# ADDENDUM No. 2: November 15, 2018

**PROJECT:** **Saint John the Baptist**
**Westbank Public Safety Complex**
**PROJECT NO.:** **STBA 21238.00**

**FROM:** SIZELER THOMPSON BROWN ARCHITECTS
300 Lafayette Street, Suite 200
New Orleans, Louisiana 70130
(504) 523-6472

## 1ST FLOOR LIFE SAFETY PLAN

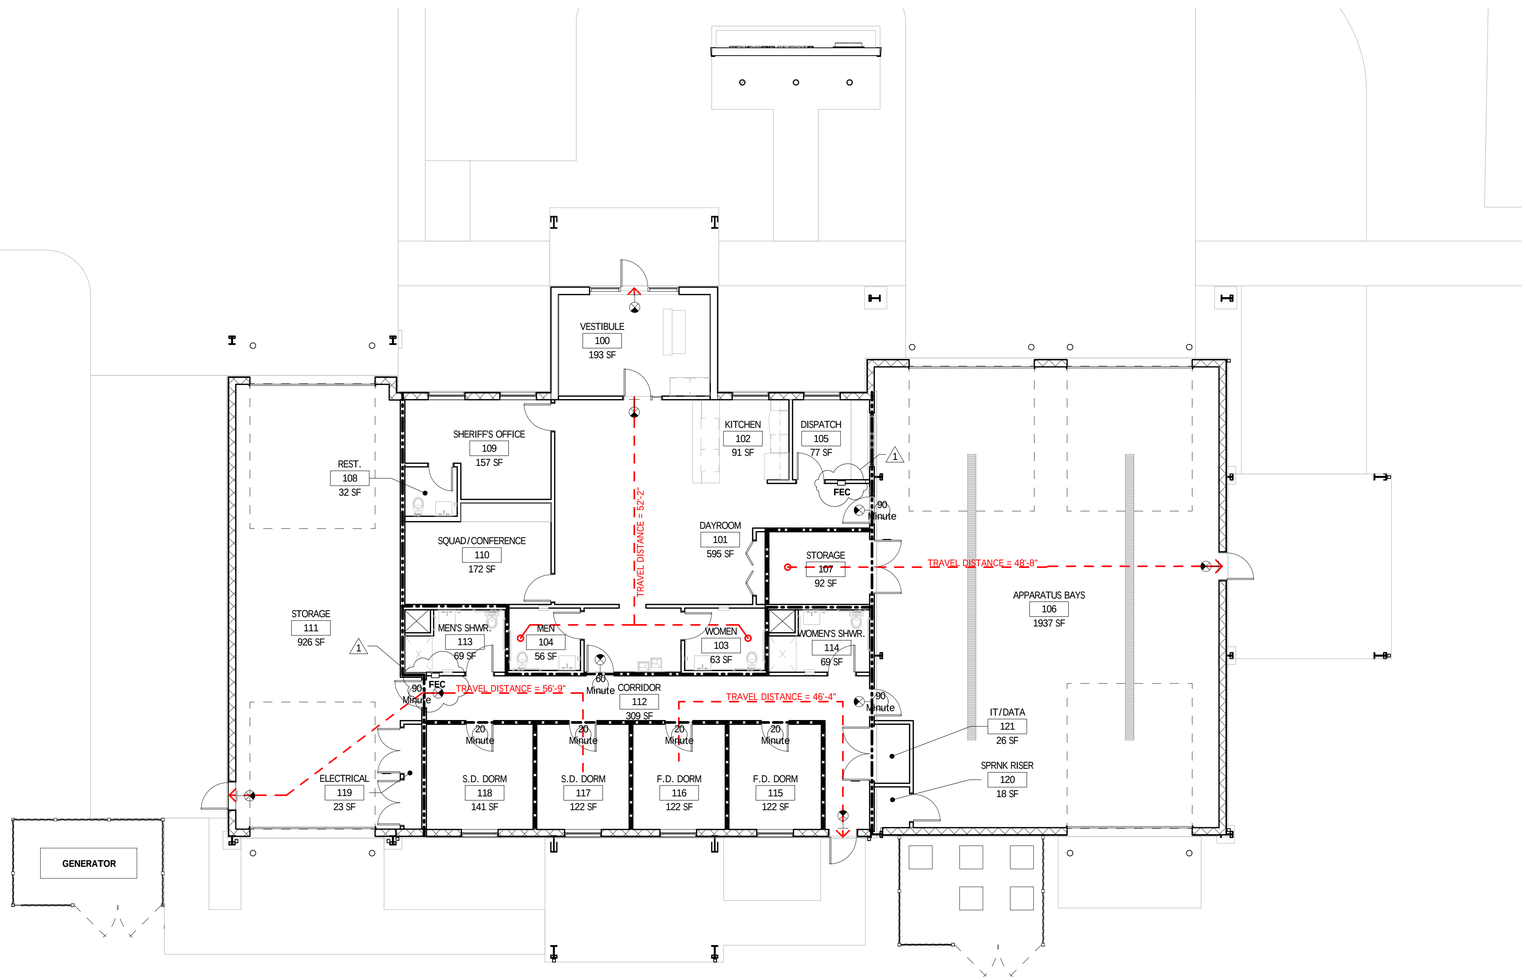
4. **Sheet G201 Fire/Life Safety Plans**

Revised drawing to indicate and identify fire extinguisher cabinets

1 A201 1ST FLOOR PLAN
1/8" = 1'-0"

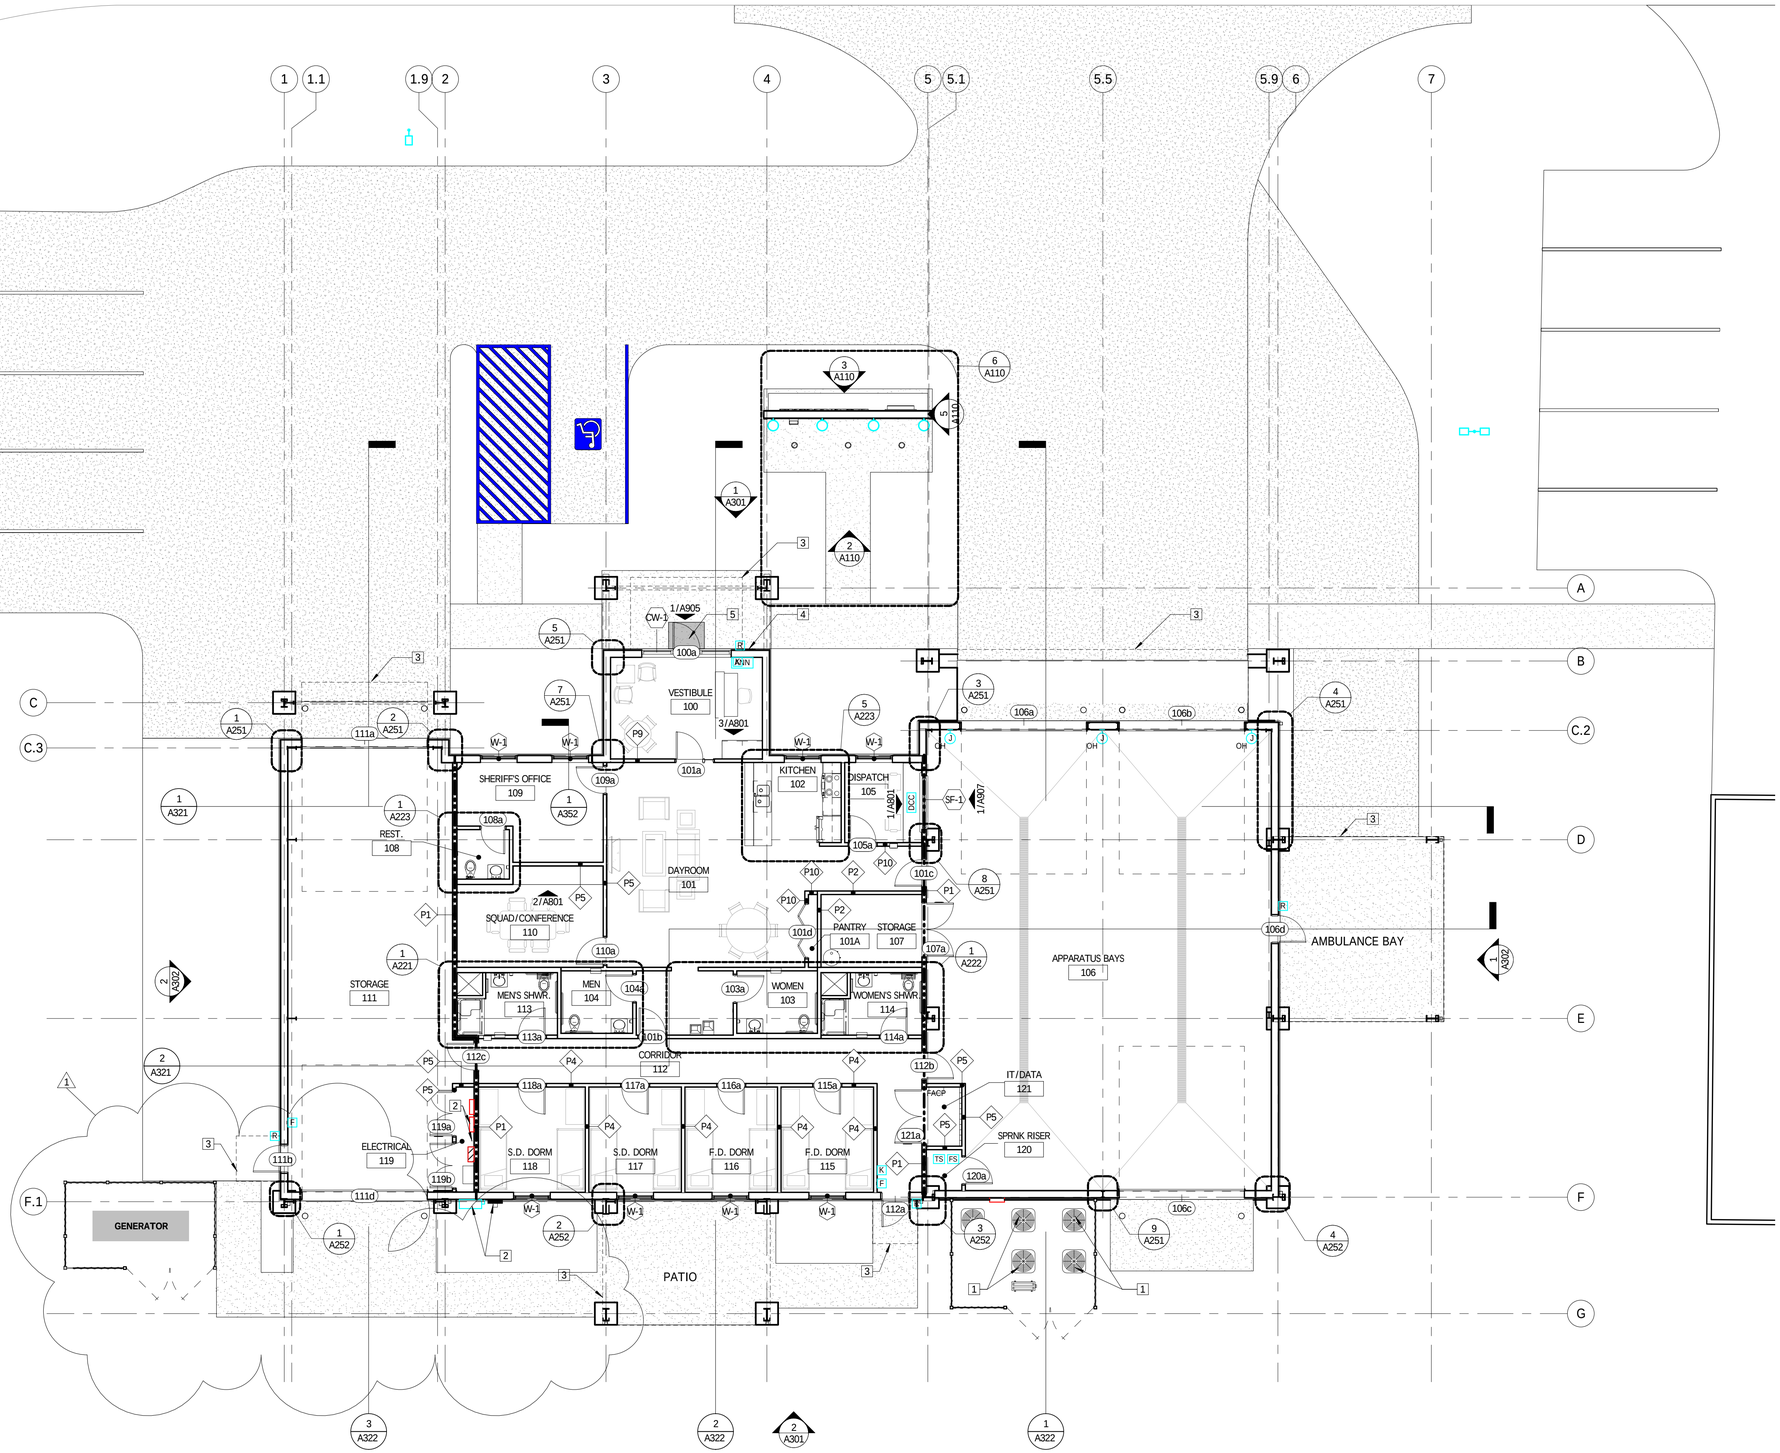
7. **Sheet A201 Building Floor Plan**

Revised sidewalk and Generator enclosure.

1 1ST FLOOR DIMENSION PLAN
A202 1/8" = 1'-0"

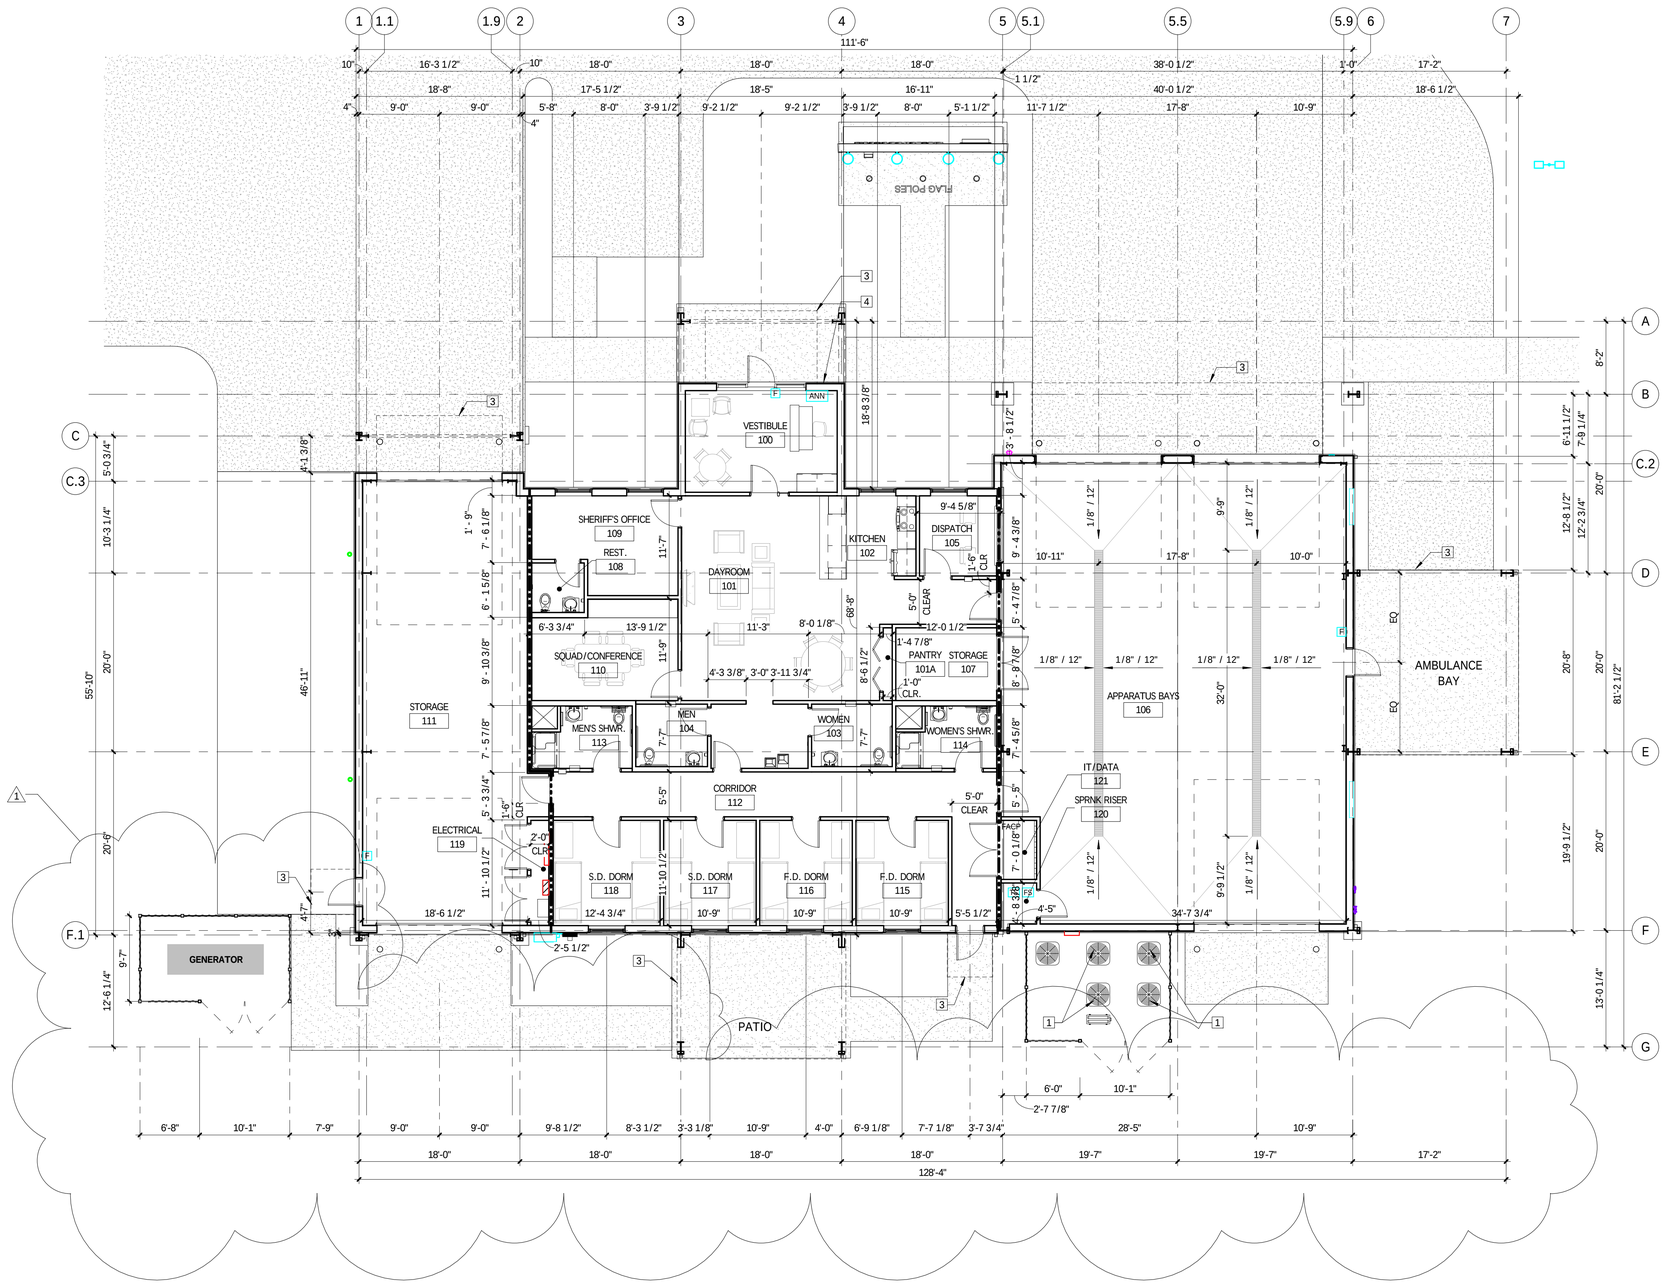
8. **Sheet A202 Dimension Plan**

Revised dimensions where indicated by clouds.

1 1ST FLOOR SLAB PLAN
A203 1/8" = 1'-0"

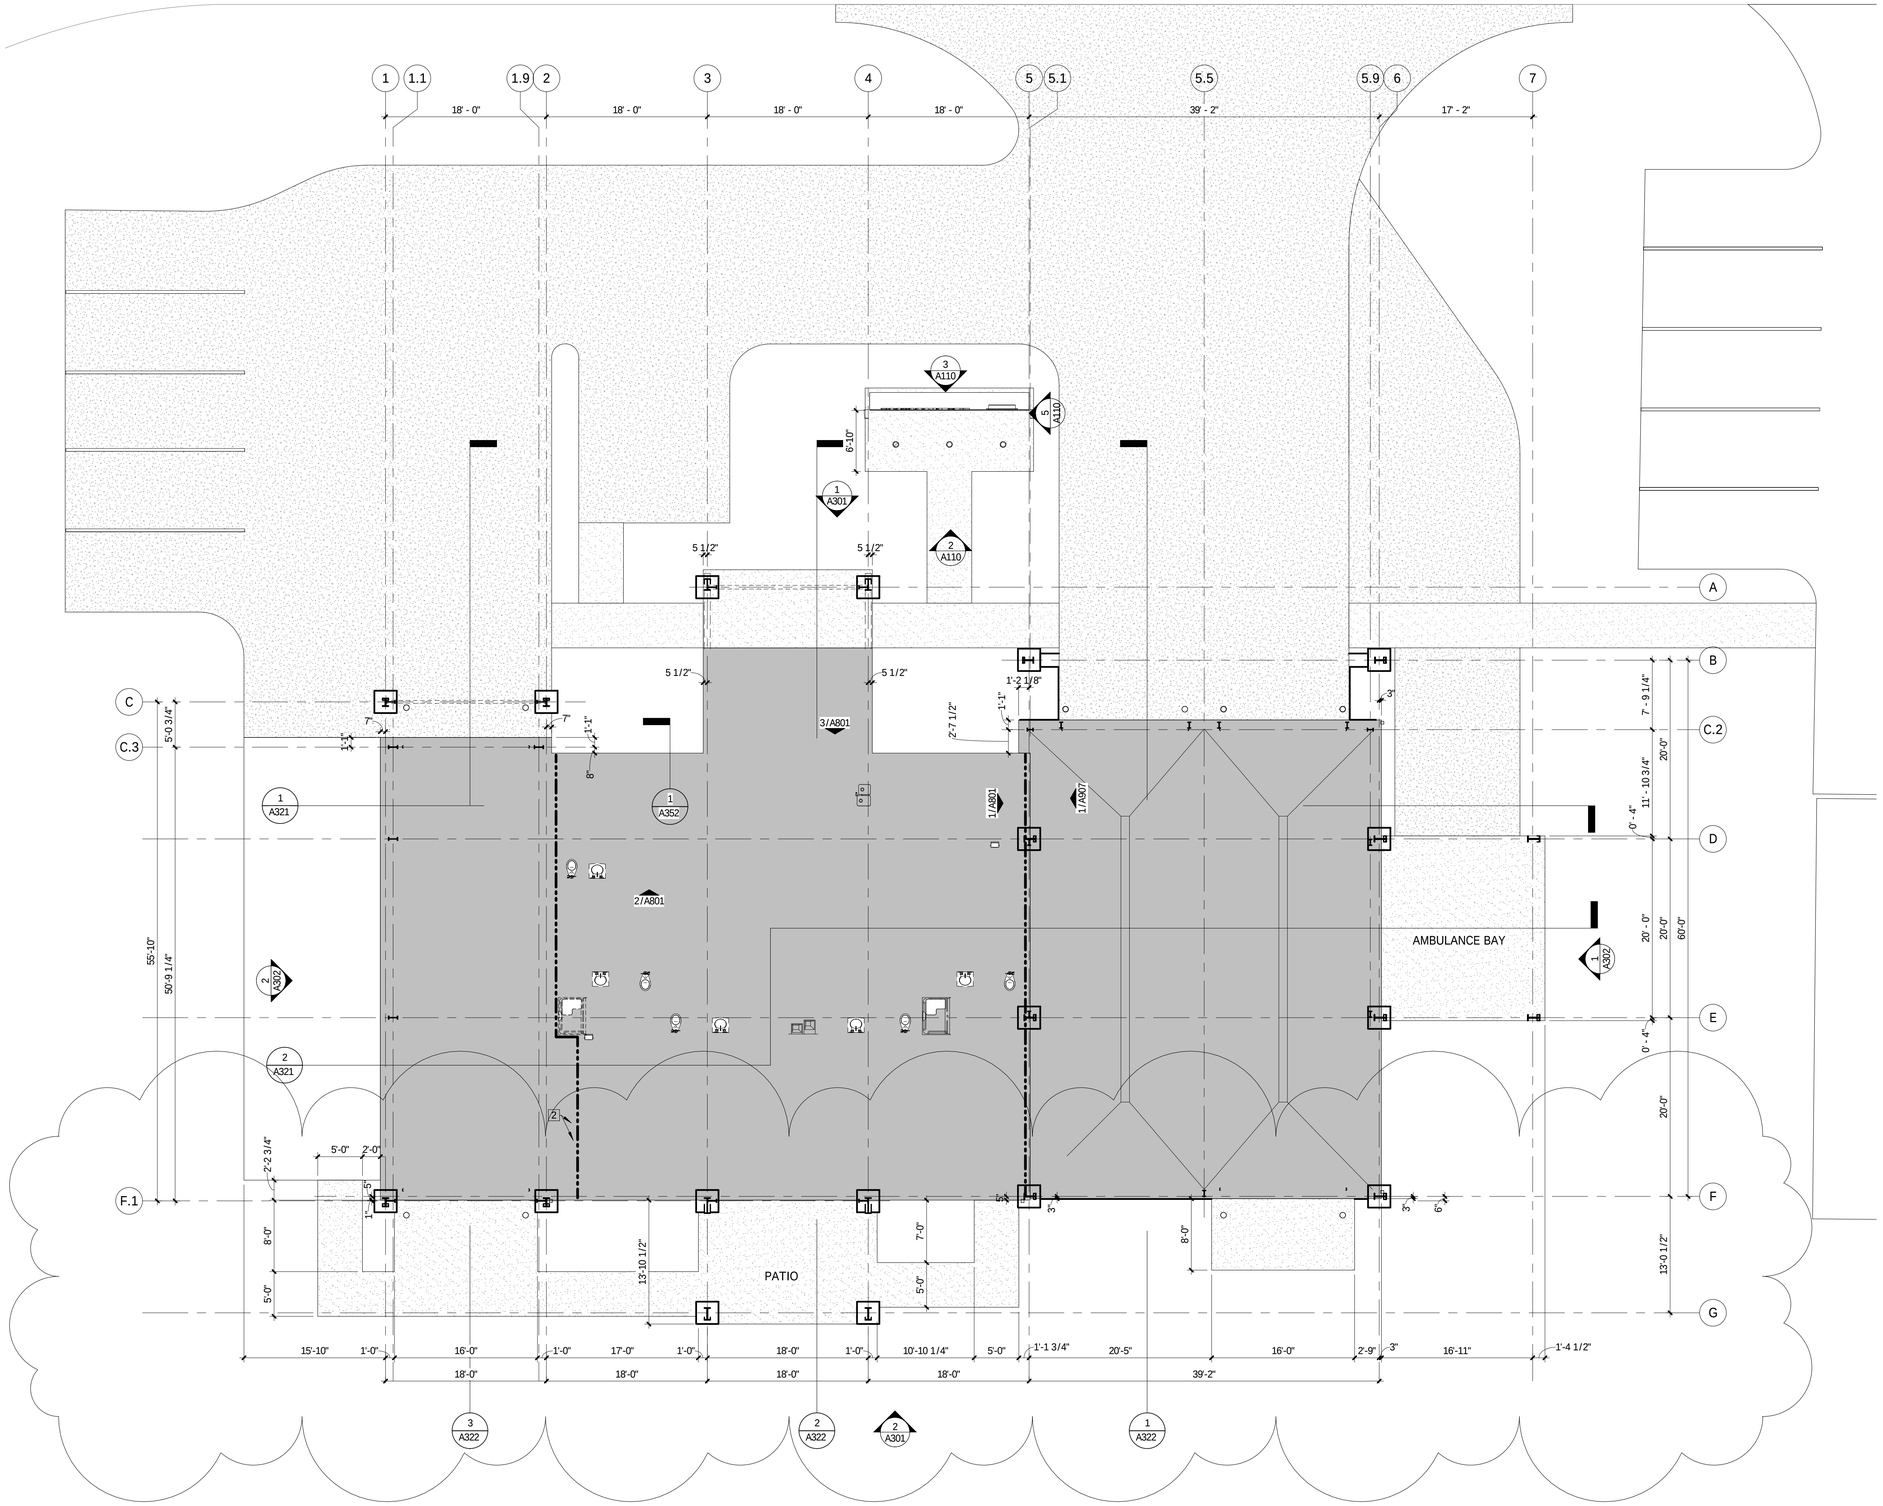
9. **Sheet A203 Slab Plan**

Revised dimensions where indicated by clouds.

1 A701 1ST FLOOR FINISH PLAN
3/16" = 1'-0"

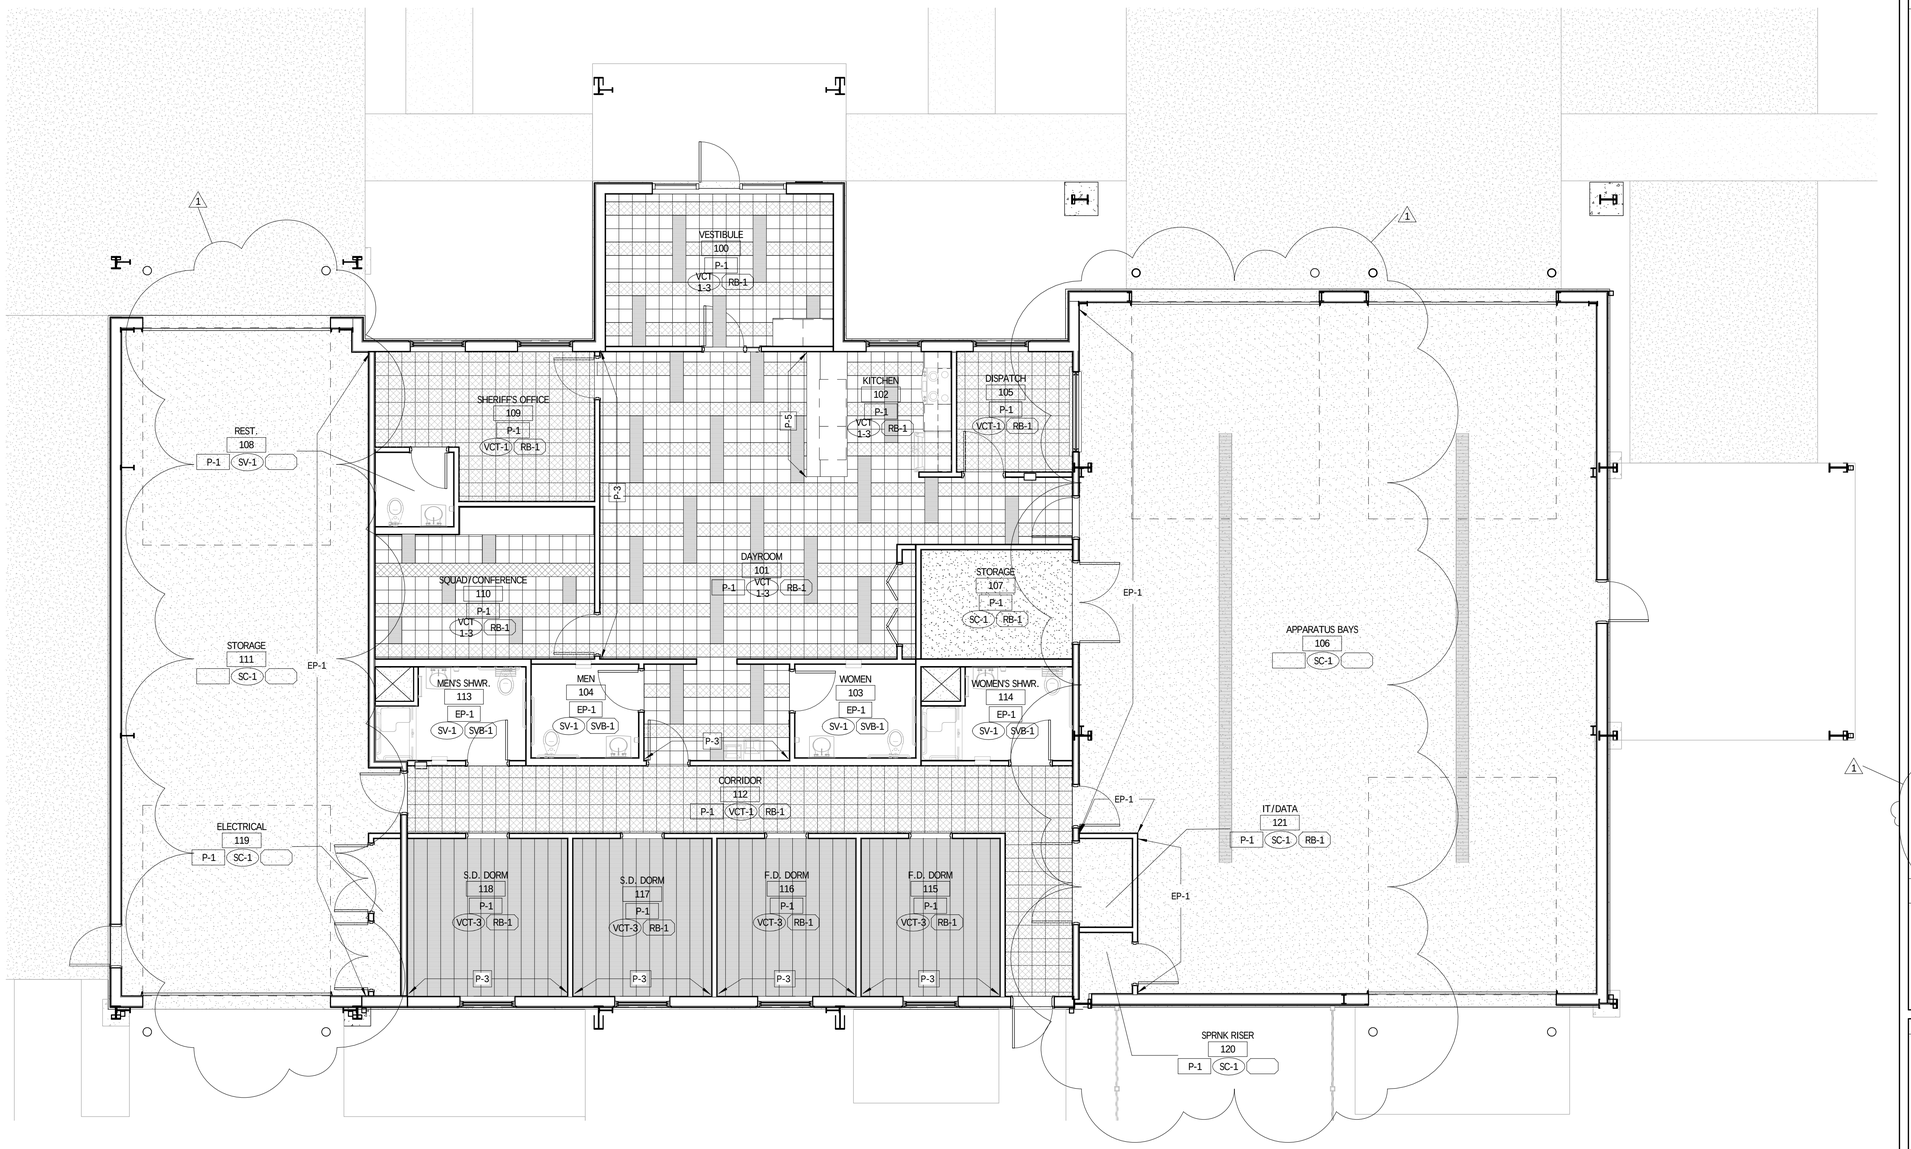
10. **Sheet A701 1st Floor Finish Plan**

Revised this drawing where indicated by the clouds.
